Project	IEEE 802.16 Broadband Wireless Access Working Group < http://ieee802.org/16 >	
Title	Comments on MS Network Entry in the MR System with the Distributed Security	
Date Submitted	2007-11-12	
Source(s)	Kanchei (Ken) Loa, Yi-Hsueh Tsai, Yung-Ting Lee, Hua-Chiang Yin, Shiann-Tsong Sheu, Youn-Tai Lee	Voice: +886-2-27399616 Fax: +886-2-23782328 loa@iii.org.tw
	Institute for Information Industry 8F, No. 218, Sec. 2, Dunhua S. Rd., Taipei City 106, Taiwan	
	[add other co-authors here]	
Re:	IEEE 802.16j-07/043: "IEEE 802.16 Working Group Working Group Letter Ballot #28"	
Abstract	This contribution proposes MS ranging and automatic adjustments in transparent and non-transparent	
Purpose	Text proposal for 802.16j Draft Document.	
Notice	<i>This document does not represent the agreed views of the IEEE 802.16 Working Group or any of its subgroups. It represents only the views of the participants listed in the "Source(s)" field above. It is offered as a basis for discussion. It is not binding on the contributor(s), who reserve(s) the right to add, amend or withdraw material contained herein.</i>

Comments on MS Network Entry in the MR System with the Distributed Security

In order to faci

Figure 1 MS network entry with distributed security and non-centralized control

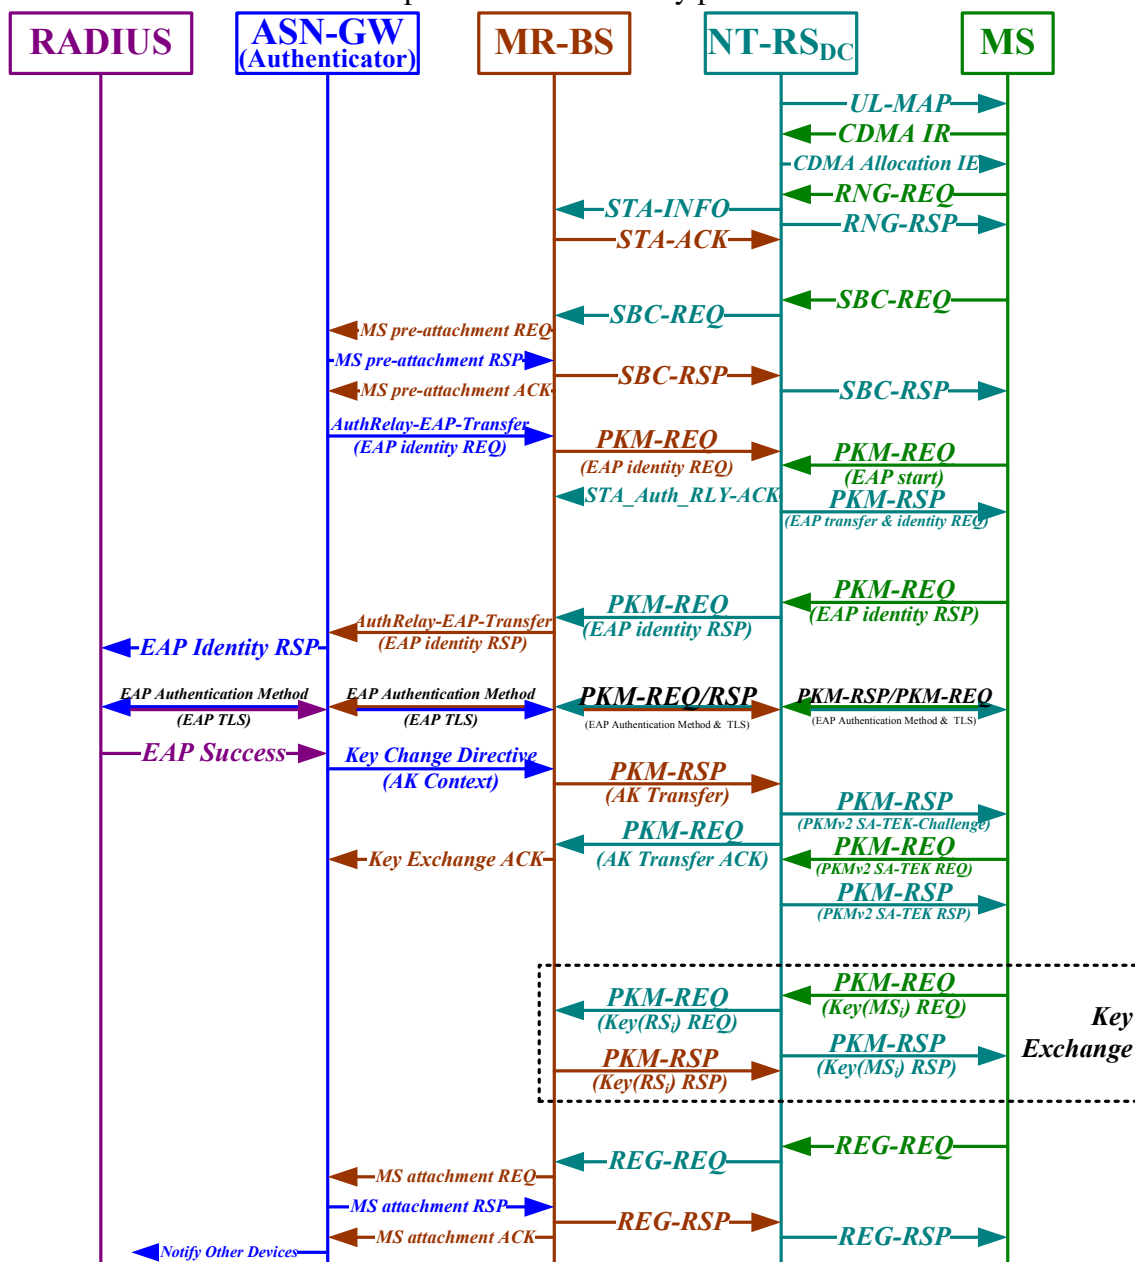
We propose this contribution to resolve the comments #667 (C80216j-07/498r2). Unlike centralized security scheme, a non-transparent RS (NT-RS) with distributed security and non-centralized control needs to accommodate messages exchanging between MR-BS and ASN-GW during MS network entry procedures. The MR-BS, which is no longer holding the AK on behalf of the RS, cannot proxy RS interactions with the ASN-GW without relaying ASN-GW messages to the NT-RS (AR-RS) that stores AK locally. The following figure illustrates messages exchanging among all entities and shows that we need new MAC messages between MR-BS and the RS in order to allow a MS complete its network entry procedures.

Figure 88b— Handling SBC-REQ at a RS except uplink-only mode and local CID allocation mode

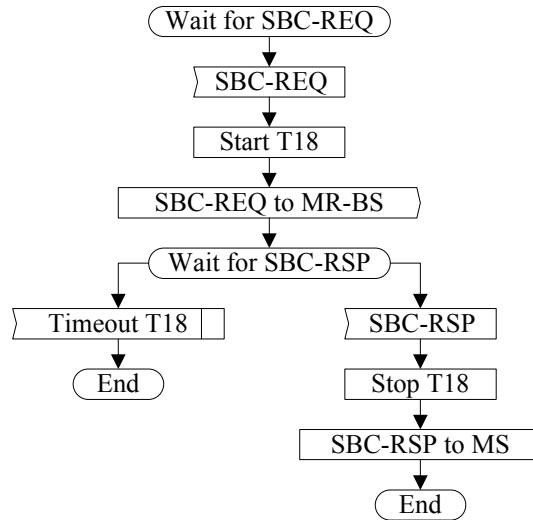
If the RS is not in local CID allocation mode, it shall forward the SBC-REQ with SS basic CID to the MR-BS after removing the TLVs it manages. The MR-BS shall determine the SS capabilities in the remained TLVs and send them in a SBC-RSP to the RS on the SS basic CID. The RS shall then fill in the TLVs it manages and forward the SBC-RSP to the SS.

Figure 88c— Handling SBC-REQ first reception at a non-transparent RS with a unique BSID under local CID allocation mode

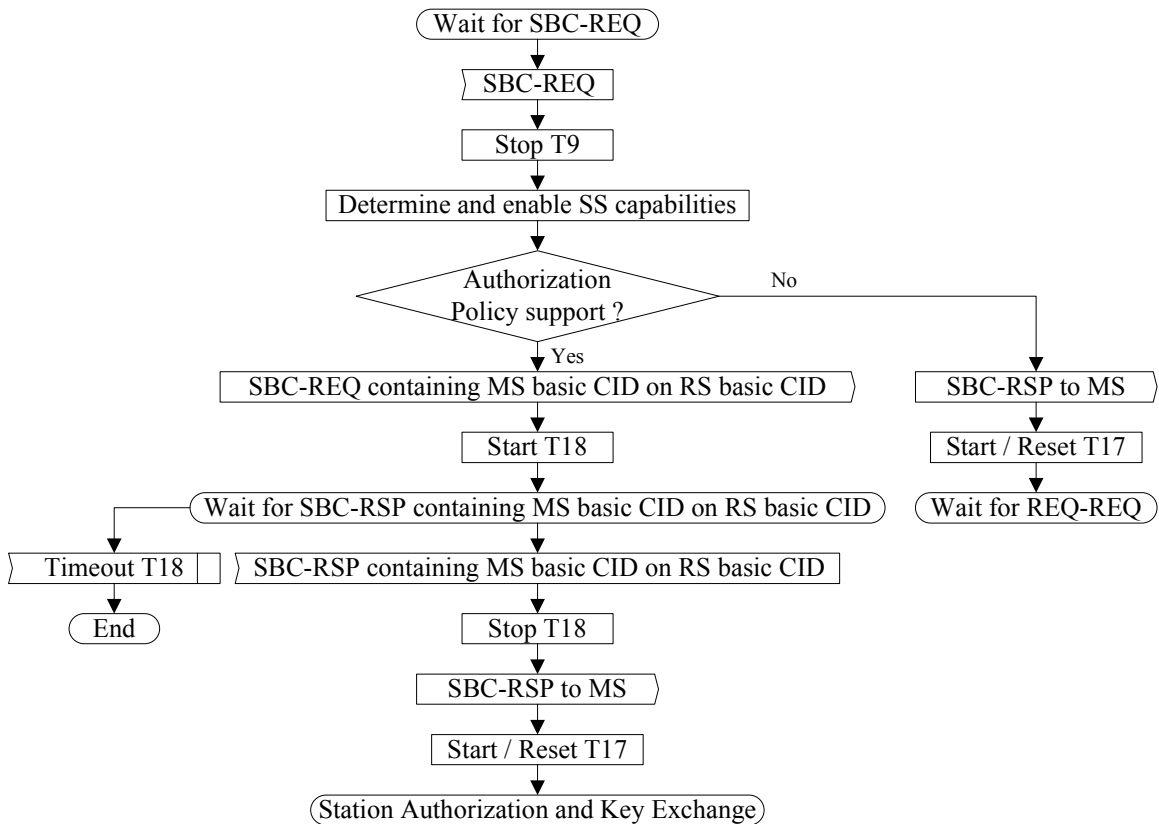
If the RS is in local CID allocation mode, the RS shall forward the SBC-REQ with RS basic CID to the MR-BS after removing the TLVs it manages and filling in the SS basic CID TLV. The MR-BS shall response a SBC-RSP containing the SS basic CID TLV to the RS on RS basic CID. The RS shall then remove SS basic CID TLV and fill in the TLVs it manages and forward the SBC-RSP on SS basic CID.

Figure 94b— Handling REG-REQ at a RS except uplink-only mode and local CID allocation mode

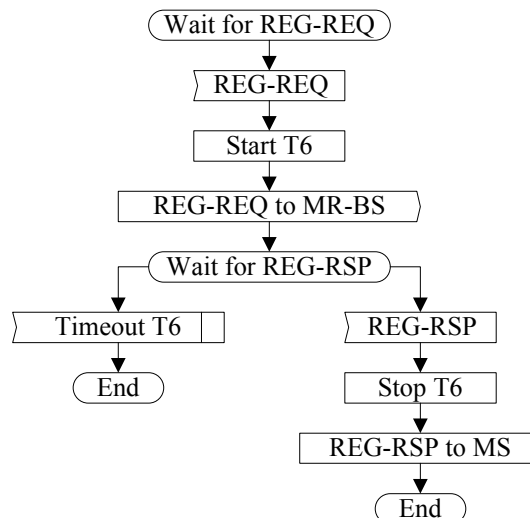
- When a RS receives an REG-REQ with the SS primary management CID, it shall either send REG-RSP to the SS directly or request them from the MR-BS.
- If the MS does not support authorization policy, the RS shall send REG-RSP to the MS directly.
- If the MS support authorization policy, the RS shall forward the REG-REQ with RS basic CID to the MR-BS after removing the TLVs it manages and filling in the SS basic CID TLV. The MR-BS shall response a REG-RSP containing the SS basic CID TLV with RS basic CID to the RS. The RS shall then remove SS basic CID TLV and fill in the TLVs it manages and forward the REG-RSP on SS primary management CID.
